Access Compliance Report

Public Rights-of-Way

(Curb Ramps)

Intersection ID: 28727	Main Street: STEWARTS_CROSSING_DR	Cross Street: TRESHAM_CT	Location:	N
ADA ID: F9930FF10688	Ramp Type: Perp	Initial Pass/Fail: Fail	Overall Compliance: No	Severity Score: 22.5
Codes/Mitigation Info/Possible Solution		Field Measurements/Component Compliance

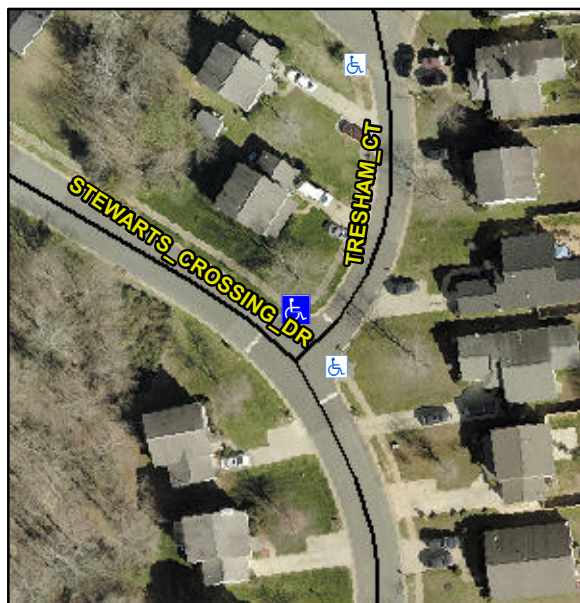
R304.5.1, R304.2.2, R304.5.3

Compliance	Description	Data	Compliance	Description	Data
N/A	Ramp Length (in)	46.5	No	Ramp Slope (%)	9.5
No	Ramp Width (in)	47.0	No	Ramp XSlope (%)	3.3
N/A	Flare Type LT	N/A	N/A	Flare Type RT	N/A
N/A	Flare Slope LT (%)	N/A	N/A	Flare Slope RT (%)	N/A
N/A	Flare Traversable LT?	N/A	N/A	Flare Traversable RT?	N/A
N/A	Landing Length (in)	N/A	N/A	DWS Provided?	N/A
N/A	Landing Width (in)	N/A	N/A	DWS Contrast?	N/A
N/A	Landing Slope (%)	N/A	N/A	DWS Length (in)	N/A
N/A	Landing X Slope (%)	N/A	N/A	DWS Full Width?	N/A
N/A	Landing Curb? (Y/N)	N/A	N/A	DWS Offset (in)	N/A
N/A	Shared Landing?	N/A			
N/A	Gutter Ponding?	N/A	N/A	Gutter Slope (%)	N/A
N/A	Gutter Lip Ht (in)	N/A	N/A	Gutter X Slope (%)	N/A
N/A	Painted X Walk1?	No	N/A	Painted X Walk2?	N/A
	X Walk 1 Direction	To S		X Walk 2 Direction	N/A
N/A	X Walk 1 Width (in)	N/A	N/A	X Walk 2 Width (in)	N/A
	X Walk 1 Slope (%)	4.3		X Walk 2 Slope (%)	N/A
	X Walk 1 X Slope (%)	1.0		X Walk 2 X Slope (%)	N/A

Remove & Replace Entire Ramp.
